SERVICE BULLETIN REVISION NOTICE

ENGINE — SEAL ASSEMBLY, NO. 4 BRG FRONT AND HOUSING ASSEMBLY, NO. 4 BRG OIL NOZZLE BLOCK AND NO. 4 BRG OIL NOZZLE ASSEMBLY — REPLACE OR MODIFY TO STOP OIL NOZZLE BLOCK HOUSING BOLTS FROM LIBERATION

Turbojet Engine Service Bulletin No. V2500-ENG-72-0629 Revision No. 3 dated February 25, 2021.

Revision 3 dated February 25, 2021

MODIFICATION OF THE NO. 4 BEARING SEAL SUPPORT ASSEMBLY, PN 2A3845
FIGURE 7, SHEET 1

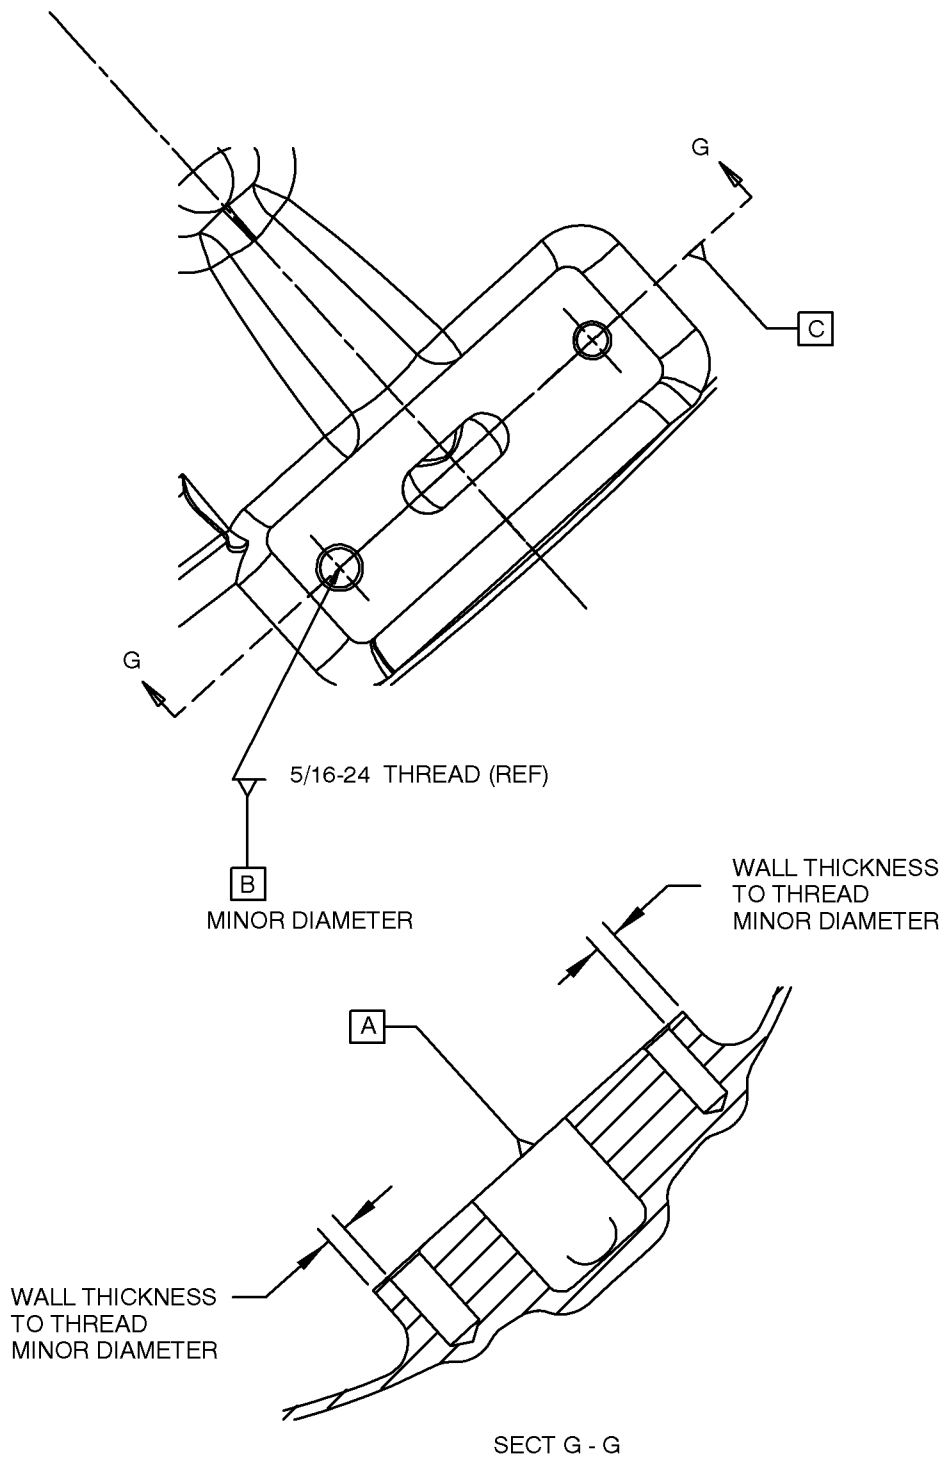
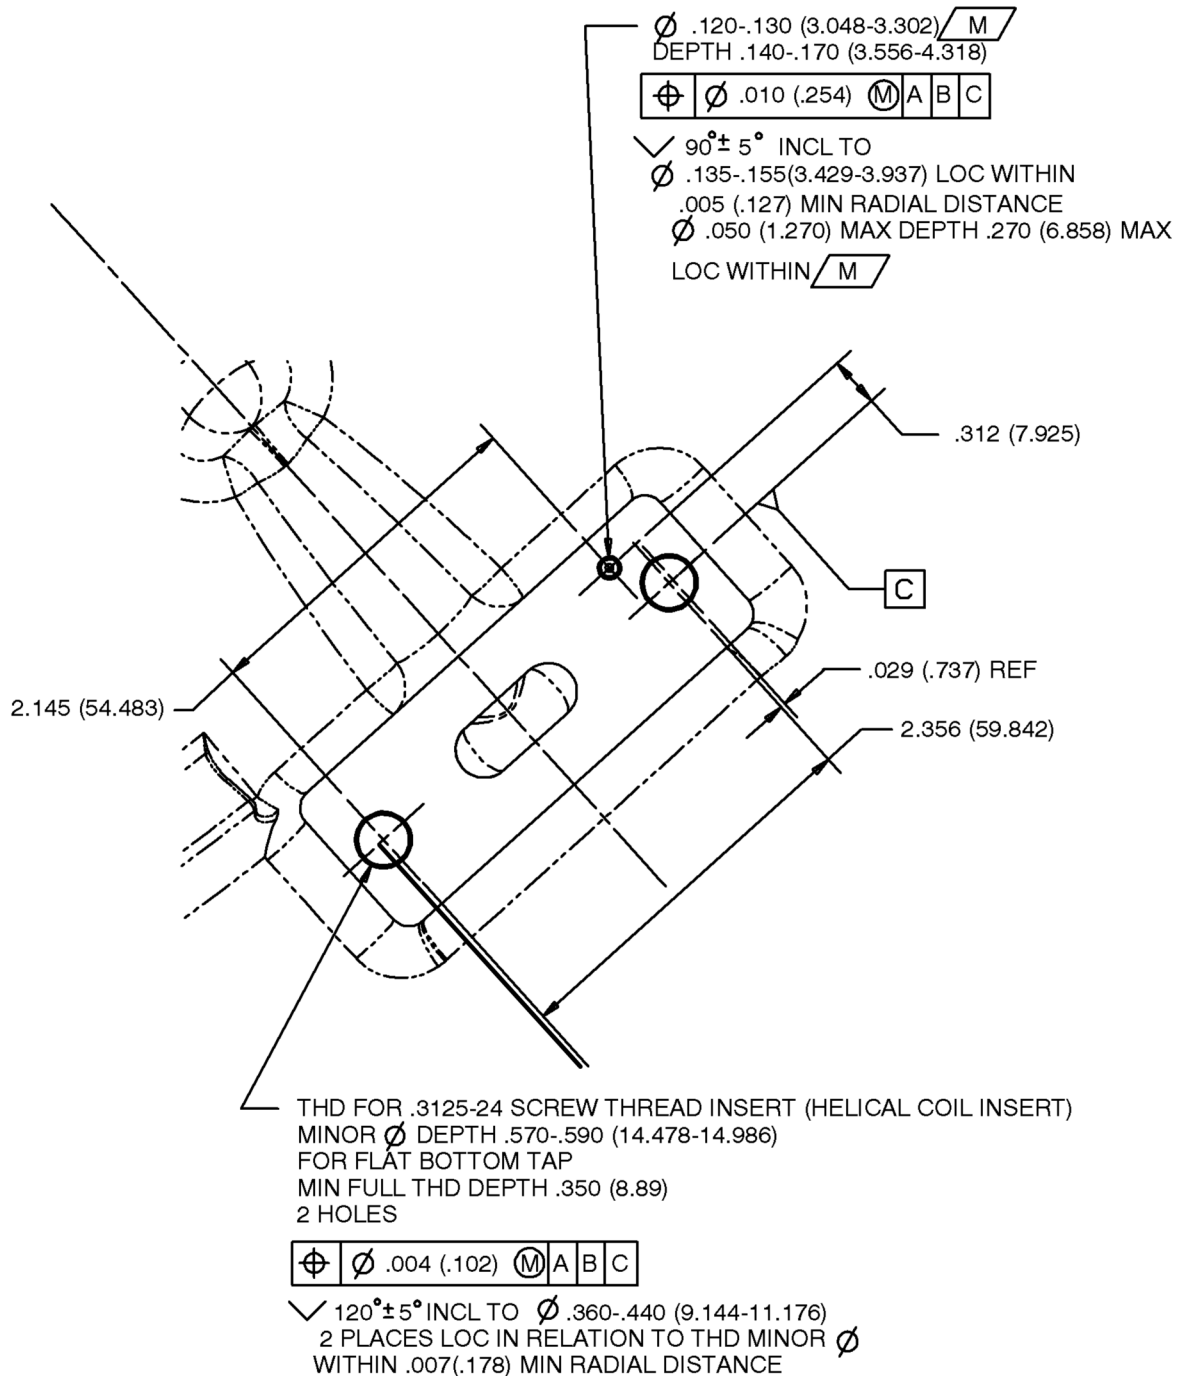
- C. Modify the No. 4 Bearing Seal Support Assembly PN 2A3845.
 - (1) Measure wall thickness from thread minor diameter to outside of boss for both holes in the oil nozzle boss of No. 4 Bearing Seal Support Assembly, PN 2A3845. See Figure 7. If wall between 5/16-24 (0.3125-24) threaded hole and outside of boss is equal to or more than 0.110 inch (2.794 mm) and if wall between 1/4-28 (0.250-28) threaded hole and outside of boss is equal to or more than 0.110 inch (2.794 mm) continue with this modification. If the wall is less than 0.110 inch (2.794 mm) for either threaded hole, stop, part is not serviceable.

- (3) Mask internal oil passages to prevent Foreign Object Damage (FOD) due to machining debris.
 - (4) Use a 21/64 [.3281 inch] (8.33 mm) diameter end mill to machine two (2) holes shown in Figure 7.

- (5) Tap the two (2) holes with a bottoming helicoil tap for a 5/16-24 (0.3125-24) screw thread insert (helical coil insert) per Figure 7.
 - (6) Measure wall thickness from thread minor diameter to outside of boss for both holes in the No. 4 bearing seal support assembly oil nozzle boss (see Figure 7). If wall is equal to or more than 0.080 inch (2.032 mm), continue with the modification. If it is less than 0.080 inch (2.032 mm), stop, part is not serviceable.

- (7) Machine a 0.125 inch (3.1745 mm) diameter stepped hole as shown in Figure 7.
 - (8) Break edges 0.003 – 0.015 inch (0.08 – 0.38 mm).
 - (9) Clean per Reference 2, V2500 SPPM Task 70-11-03-300-503.

To revise the minimum wall thickness for both holes in the oil nozzle boss in the Accomplishment Instructions.
